## ACCESS/COMPLIANCE/DESIGN STATEMENT

21<sup>st</sup> November 2019.

SITE ADDRESS; 4 Mowanba Place Thredbo, Bernti's BAR

Accessible (disabled) sanitary facility;

FIGURE 43 CIRCULATION SPACE FOR WC PAN—RIGHT-HAND TRANSFER (LEFT-HAND TRANSFER IS MIRROR REVERSED)

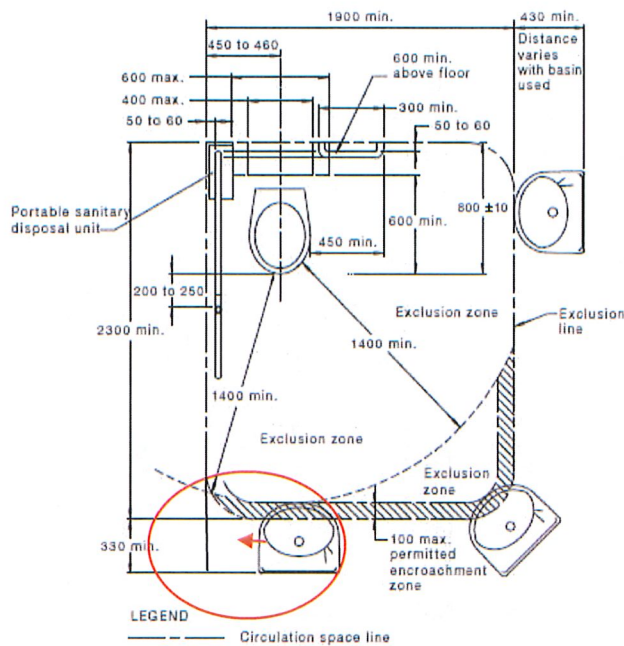
The design of sanitary facility (shown below) with the entry door opening outward and from an area outside any circulation requirements/exclusion zones and a AS1428.1 compliant corner basin allows for a 1540mm clear circulation area and 1400mm "exclusion zone" between the pan and basin with 800mm minimum (AS1428.1 Figure 1 wheelchair footprint 90 percentile) beside the system for wheelchair side transfer.

- ii. Present is proposed the “exclusion zone arch” of 1400mm in front of the pan to basin to opposing wall.
- iii. The toilet pan will be in the correct position as per **AS1428.1-2009 Design for access and mobility Clause 15.2.2 WC pan clearances & Figure 38 Water closet pan clearances, seat height and width** at 790mm to front of pan & 450mm-460mm centre from the side wall & the seat 460mm-480mm high.

- iv. The grab rails are to be fitted correctly at pan for position and design compliant with **AS1428.1-2009 Clause 15.2.7 & Figure 42 Position of grab rails in water closet** as with all other fittings and fixtures including the hand dryer, basin, a shelf and a cloth hanger.

- v. The clear turning circle requirement of **1540mm** (Red dashed circle) will be present to comply with **AS1428.2 Clause 6.2 (full 180° turn would be in one manoeuvres from stationary thus turning length of 2070mm not applicable)** and **AS1428.1-2009 Design for access and mobility Clause 6.5.1** for <90° turn for manoeuvring to close door and face the pan and the floor with a slip resistant surface as specified in **AS1428.1 Clause 12 Surface on a continual accessible path of travel.**

FIGURE 5.2 PREFERRED DESIGN ENVELOPE AROUND PARKED VEHICLE TO BE KEPT CLEAR OF COLUMNS, WALLS AND OBSTRUCTIONS

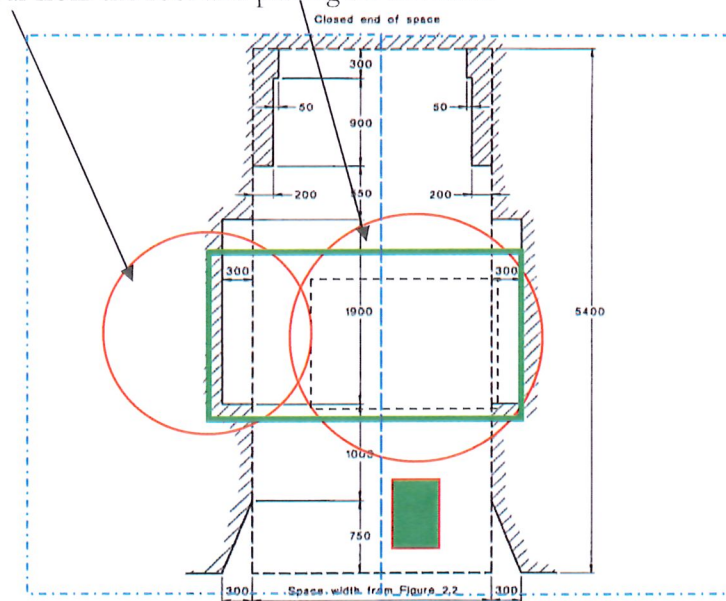
- In this proposed instance a garage is provided for the manager and six spaces for the “general public” residents of the hotel/bar and as there is a history, for hotel, of no usage of an accessible (disabled) car space it is proposed, an allowance, to not designate/sign the sixth space as a an accessible (disabled) car space (Allowance under **NCC 2019 Part D3.5 Accessible Car Parking (d) for 5 spaces**) but have adjoining space designated/signed as a “shared area.

- Arrangements could be made with management by a visitor who requires it as an accessible (disabled) car space to reserve it for their use.
- □ As six vehicle parking spaces are proposed for employees and visitors the NCC 2019 Part D3.5 *Accessible Car Parking (d)* allows, when spaces no more than five, for an accessible space not to be “identified with signage so as to restrict the use of the parking space only for people with disability”.

- □ This means no “shared area” is required, space is provided, beside any space and the/all parking spaces can be technically and feature designed to comply with the parking space of AS2890.2009 Part 6 *Parking facilities-Off street parking for people with disability* Section 2.2 *Parking space-dimensions* Point 1 *Angle parking spaces*.

- The parking space accessible (disabled) car space (required only as accessible when an accessible unit in hotel is occupied by person with disability/wheelchair user) is also design compliant with the clear space (Clear of column) requirements of AS2890.1 *Off street parking* for placement of the wheelchair after removal from the roof and placing on the floor.
